Wollongong Local Planning Panel Assessment Report | 17 May 2022

WLPP No.	Item No.6
DA No.	RD-2006/1376/A
Proposal	Review of Determination – Modification of consent to allow for <u>retrospective approval of works already undertaken</u> , including an increase in the FFL of all floor levels of the dwelling, increase in overall building height, installation of an internal lift, enclosure of roof top terrace with windows, increase in floor area of garage/basement level and addition of storage room in garage/basement level
Property	Lot 11 DP 285763, 13 Weaver Terrace, Bulli NSW 2516
Applicant	Plannex Environmental Planning
Responsible Team	Development Assessment & Certification – Building and Certification Team (EF)

ASSESSMENT REPORT AND RECOMMENDATION

PLAN OF BASEMENT & GARAGE

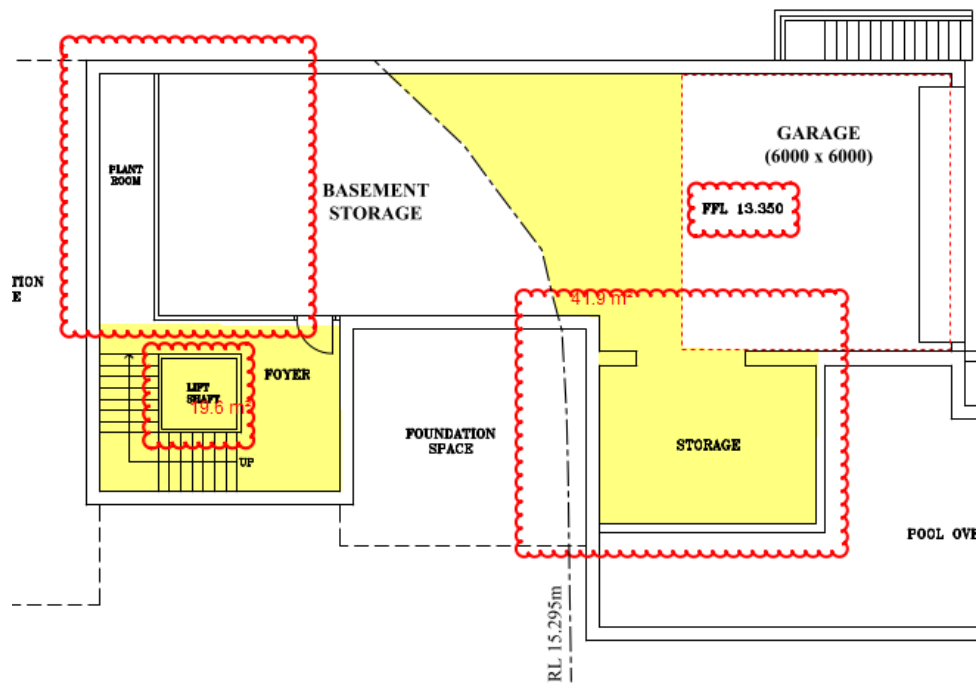
Maximum FSR permitted for the zone:	0.50:1
FSR calculated:	Garage/Basement Level = 61.5m ²
	First Floor = 159.9m ²
	Second Floor = 149m ²
	Terrace Level = 40.5m ²
	409.9m ² /711m ² = 0.577:1
	Exceeds 0.50:1 by 15%

All areas highlighted in the below images have been included in the calculation of **gross floor area** as per the definition within WLEP2009. The areas not highlighted within the garage/basement level have been excluded in accordance with the WLEP2009 definition of a **basement**, and areas within a basement which can be excluded, in addition to the 36m² of required car parking that has been excluded. A contour level has been illustrated on the garage/basement plan to allow for accurate delineation of the area within the garage/basement area, which meets the WLEP2009 definition of a basement.

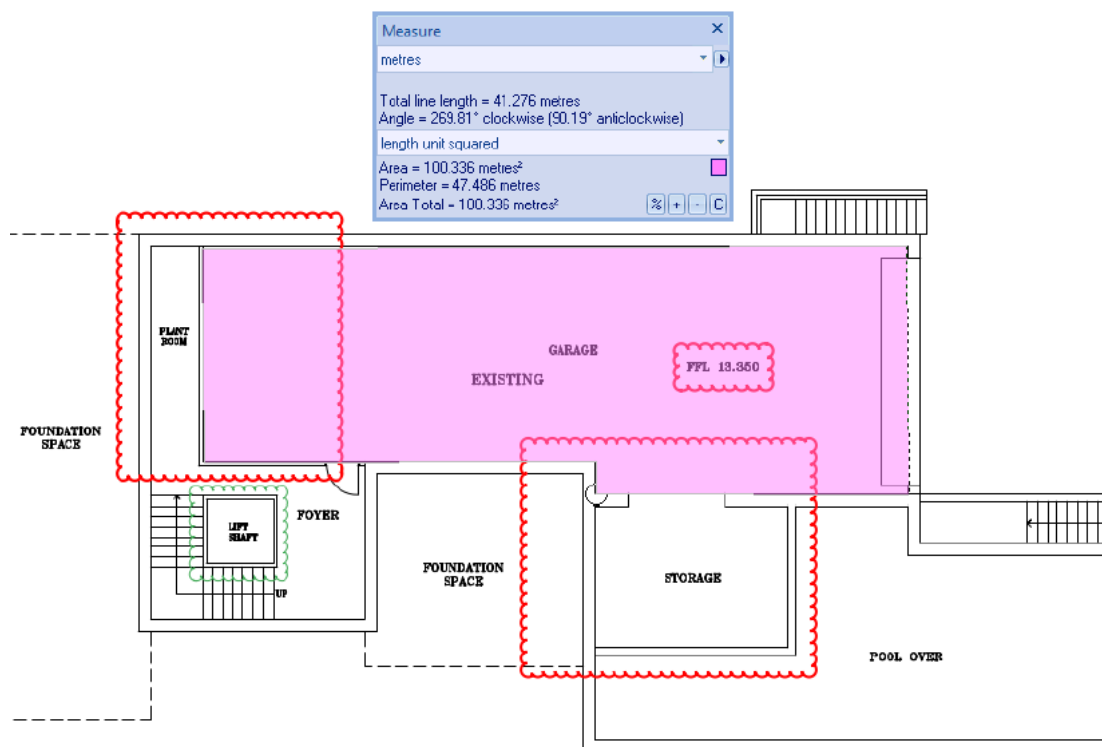
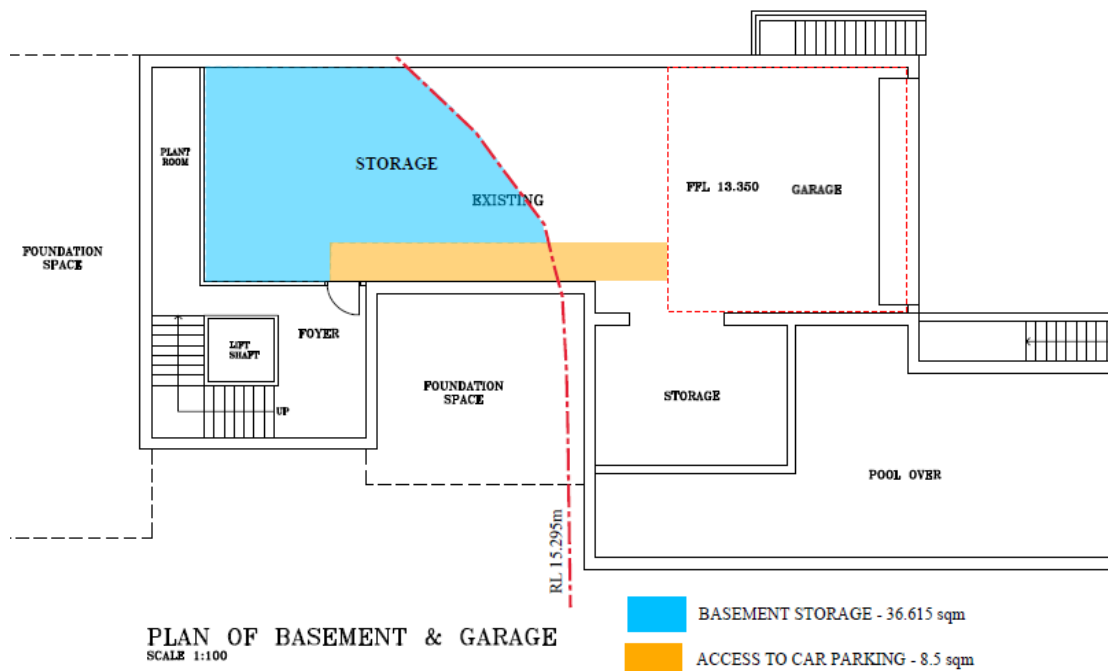
The assessment report included diagrams that detailed which areas of each floor had been included as GFA for the purposes of the calculations. In relation to the garage floor level, the relevant GFA diagram is shown below.

Part of the pink shaded area is basement storage space and part serves as access to the car parking spaces. As allowed for in the definition of “*gross floor area*”, these areas should be excluded from the calculated GFA and FSR. The floor plan extract below shows these areas.

The basement storage area has been taken as that part of the garage floor level where the finished floor level above (ie RL 16.295m AHD) is not more than 1m above ground level (existing) – ie that part of the floor located on land where the pre-development site level was RL 15.295m AHD or greater. This is consistent with the definition of “*basement*” in the Dictionary to WLEP 2009:-

DA-2006/1376/D

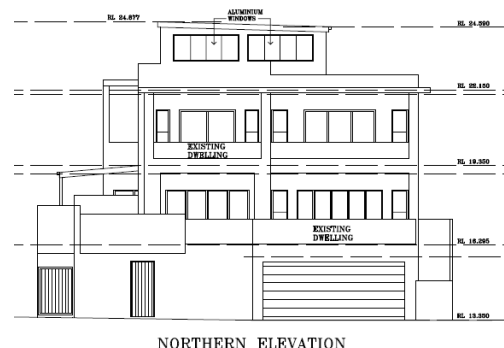
The changes to the approved development arising from the installation of a lift within the dwelling house, the provision of windows to enclose the uppermost level, and an overall increase in building height of between 140mm and 427mm, do not materially alter the form or scale of the dwelling house to the point where it is unacceptable when compared to the approved development.

Figure 2 *Surveyed Roof Levels and Building Heights*

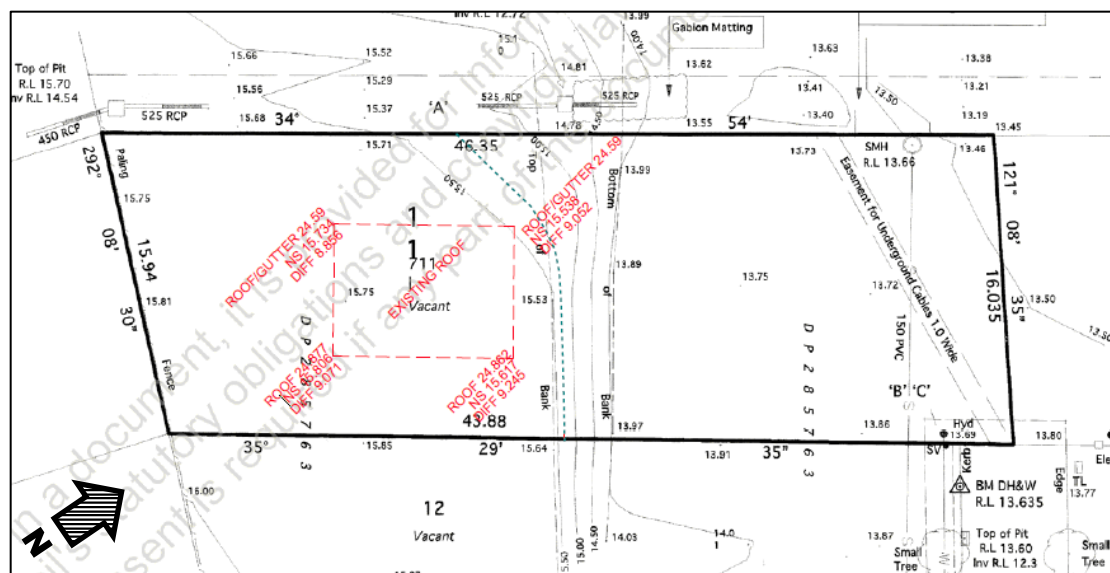
The existing dwelling house has been constructed with floor levels higher than those approved under the original DA-2006/1376. The difference in floor levels between the approved development and the existing development is summarised in the table below.

Section of Roof	Surveyed Roof Level	Ground Level (Existing)	Overall Height	9m +/- Differential
North-East Corner	RL 24.862m AHD	RL 15.617m AHD	9.245m	+245mm
North-West Corner	RL 24.590m AHD	RL 15.538m AHD	9.052m	+52mm
South-West Corner	RL 24.590m AHD	RL 15.734m AHD	8.856m	-144mm
South-East Corner	RL 24.877m AHD	RL 15.806m AHD	9.071m	+71mm

Image 1 – Approved dwelling house (left) and as-constructed dwelling house (right).

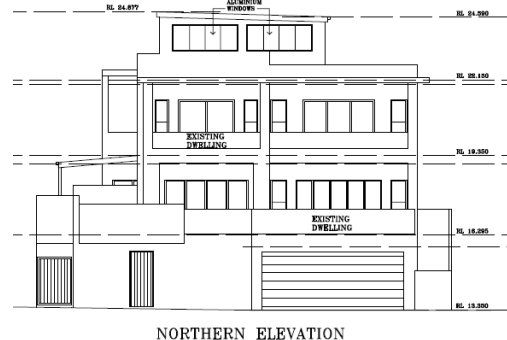
The changes to the approved development arising from the installation of a lift within the dwelling house, the provision of windows to enclose the uppermost level, and an overall increase in building height of between 140mm and 427mm, do not materially alter the form or scale of the dwelling house to the point where it is unacceptable when compared to the approved development.
